Illustrated Parts List - IPL Update

T540XP11

1. Tank vent, assy.

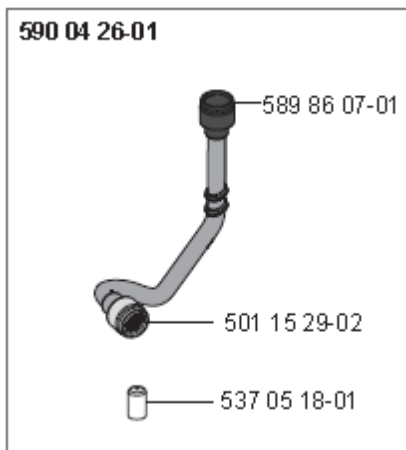
1. New Tank vent assy, kit 590 04 26-01 has been introduced. The new Tank vent assy will improve starting during warm conditions.
2. New Radial seal 588 13 97-01 due to change of supplier. The inside diameter is smaller on this new seal.

New version.

Old version.
